Contract #: 04-0120F4
 Cty: SF/ALA Rte: 80 PM: 13.2/13.9
 File #: 69.25B

QUALITY ASSURANCE -- NON-CONFORMANCE REPORT

Report No: NCR-000821

Reference Description: ZPMC performed repair on Segment 9BW without following the CWR and shop drawings

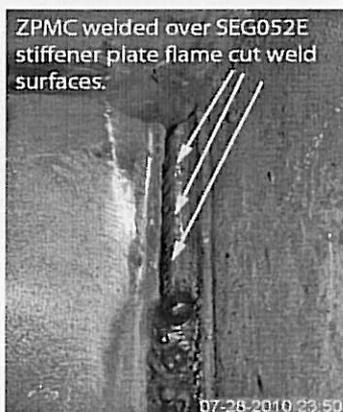
During random in process observation of the trial assembly for OBG Crossbeam 11 and Segment 9BW, this Quality Assurance (QA) Inspector discovered the following issues:

-ZPMC personnel have used acetylene/oxygen torches to remove the edge plate (EP144B) to deck plate stiffener (X8E) weld joints in Segment 9BW without following the repair procedure in the CWR.

-The B-CWR1731 states that the welds will be removed using Gouging or Grinding methods.

-ZPMC did not remove the welds, rather, cutting the stiffeners approximately 10mm to 15mm away from the welds.

-After the cutting of stiffeners, ZPMC introduced a new weld joint by welding over the flame cut surfaces. This additional weld joint is not detailed on the approved shop drawings and welding details.

-ZPMC has not documented the completion of visual or magnetic particle inspections of the weld grooves prior to welding as required by B-CWR1731.

Contractor will remove the inaccurate CWR repair area, and repair the area with approved CWR. Contractor will provide the NDT report to show the welds are acceptable. Contractor will discuss with the inspectors to aware the Critical welding repair procedure and process. Disciplinary action will be taken, if the inspectors violate the procedure and process.

Contractor removed the inaccurate CWR weld, and repair the weld accordance with a revised CWR. Contractor discussed with the inspectors the proper CWR procedure and process, and what consequence if the inspectors violated the procedures and process.
